То:	Members of the General Committee
From:	Cynthia Fletcher Commissioner of Infrastructure and Planning Services
Meeting Date:	January 20, 2020
Subject:	Report IPSPL19-033B Zoning By-law Amendment - 51 Lansdowne Street West Update

A report to update Council on the review of the file for the property known as 51 Lansdowne Street West relating to the Zoning By-Law Amendment Application.

Exhibit A – Concept Site Plan – Page 1 of 1

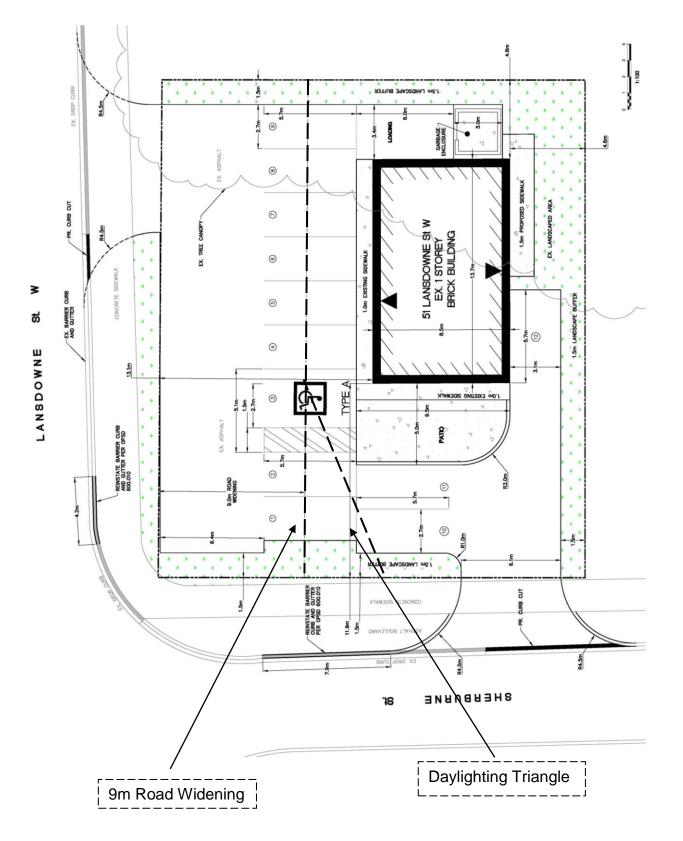
Regardless of the future road widening, the revised concept site plan presented by the applicant does not work. While the applicant's concept site plan illustrates 12 parking spaces and a loading space, there would have to be modifications to the site plan to facilitate access to the loading space, adequate turning movements and additional walkways (to Sherburne) for pedestrian traffic which would also reduce the parking below the required number.

In addition, it is noted that the Concept Site Plan shows the required loading space, blocked by two parking spaces, flanking the north side of the building. This illustrates the constrained nature of the site, where conflicting uses are intended for the same space. The applicant also indicated verbally, at the December 2nd General Committee meeting, an intent to include a patio on the site. This inclusion would be another example of conflicting uses competing for the same space. Neighbouring residents have expressed concern over the idea of patio space. There are examples throughout the City, whereby prescribed road widening has been accommodated via rezoning and site plan approval. In some cases, the City has agreed to allow the owner to park within the road allowance in the interim via lease arrangements or encroachment. In these cases, the lease arrangements or encroachments have been on larger sites where additional parking is available or the site can be reconfigured. For this property more than 80% of the required parking is subject to the conveyance, rendering the use of the lands as unusable.
